**Re: Arborist Peer Review of the Head Royce School project, Oakland**

This report comprises an independent arborist opinion regarding the proposed Head Royce School (HRS) South Campus project at 4368 Lincoln Avenue. My scope of work involves reviewing the relevant tree-related documents to provide my opinion regarding their content and conclusions. I focused on the latest arborist report by H.T. Harvey & Associates, but also reviewed other documents where relevant. I was also asked to determine how many trees could be saved if a proposed amphitheater and a portion of the loop road were eliminated.

Figure 1. The Tree Disposition Plans in the DEIR Biological Resources chapter (left) display tree locations and recommendations on the proposed site plan, while the Tree Disposition Plans in the H.T. Harvey report only show existing conditions (right).

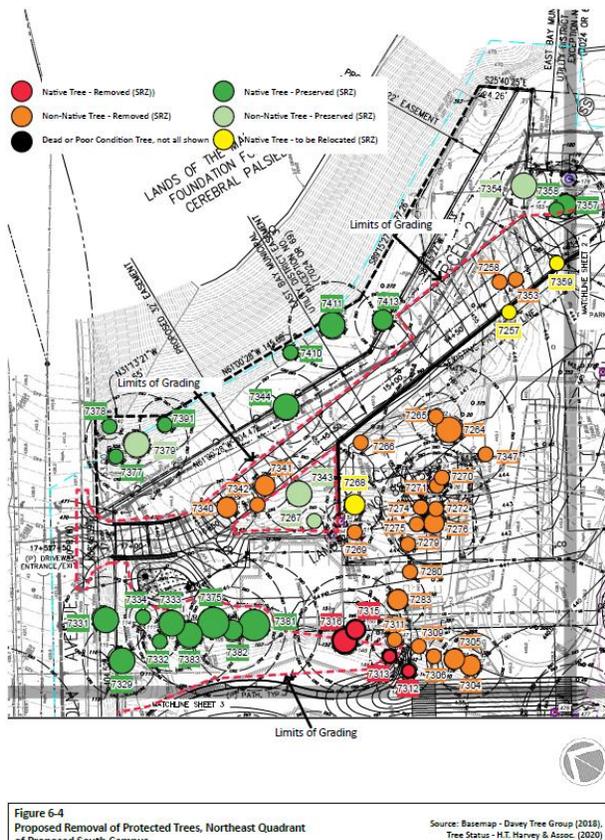
The DEIR BR chapter discusses the impact of the proposed project on protected trees, in accordance with the City of Oakland's Protected Trees Ordinance Chapter 12.36. Figures 6-4 to 6-8 in the chapter consist of tree disposition plans drawn over the proposed site plan (Figure 1, left); the site plan is based on a 2018 base map by DRG. These tree disposition plans are much more detailed – I was able to easily compare the locations of the trees to the proposed construction. By contrast, the H.T. Harvey tree disposition plans only show the tree locations on existing satellite imagery (Figure 1, right).

**Figure 6-6**  
**Disposition of Protected Trees, Northwest Quadrant of Proposed South Campus**  
 Source: Basemap - Davey Tree Group (2018), Tree Status - H.T. Harvey & Assoc. (2020)

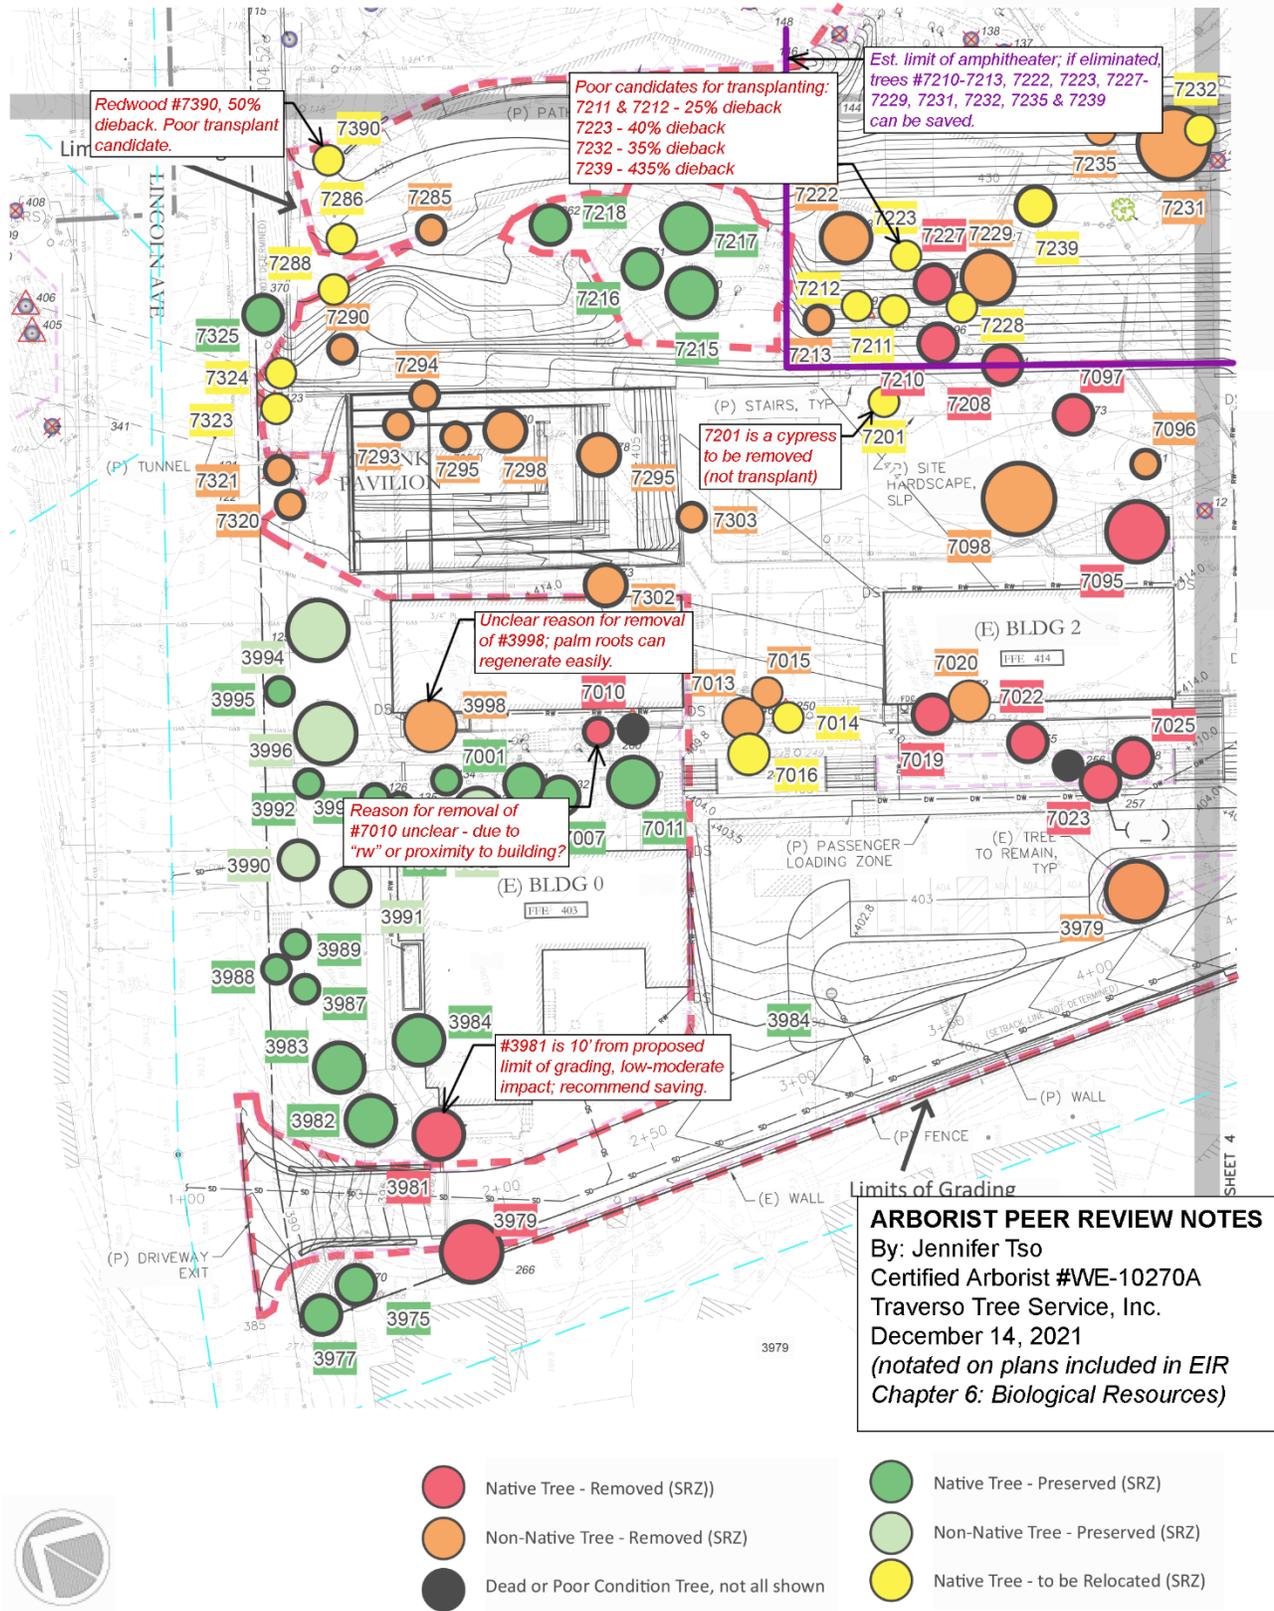
Five plans are attached, which consist of my review notes drawn on the BR tree disposition plans. The limits of the amphitheater and loop road discussed above are also shown on the plans.

**Figure 6-7**  
**Proposed Removal of Protected Trees, Southwest Quadrant of Proposed South Campus**

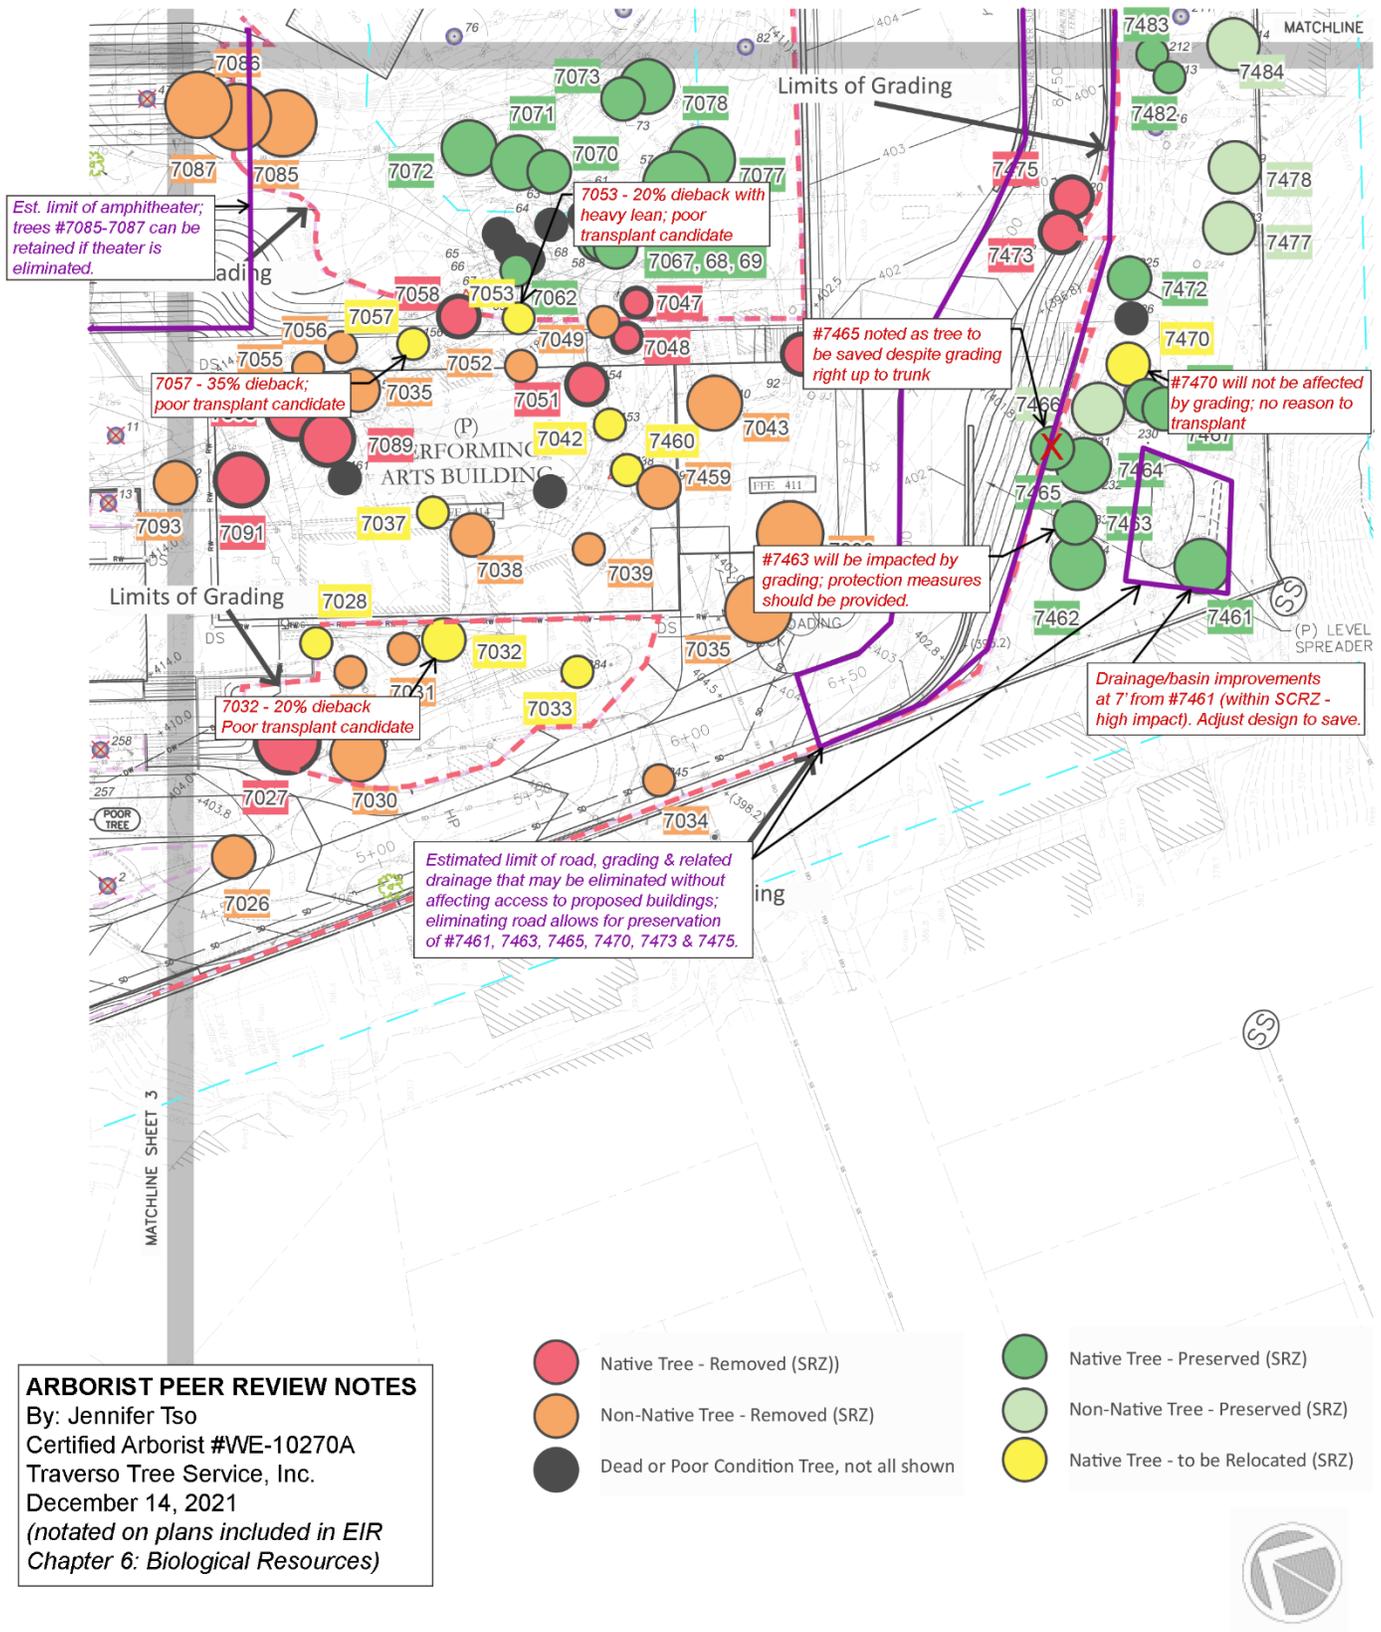
I was also asked to determine how many trees could be preserved if the proposed amphitheater and a portion of the loop road was eliminated. A conservative area around the amphitheater area was identified for assessment by consulting Leila Moncharsh. The purpose of the “loop” of the road is to direct vehicles around the South Campus perimeter and reduce crowding on Lincoln Avenue, but it may not be integral to the function of the road. To maintain access to the Performing Arts & Building 9 parking lots, only the south end of the road was eliminated for this exercise.

Twelve (12) protected trees, including three native redwoods and oaks, could be preserved if the south end of the road was not constructed. If the amphitheater were eliminated, twenty-three (23) protected trees could be preserved, including twelve (12) native oaks and redwoods.
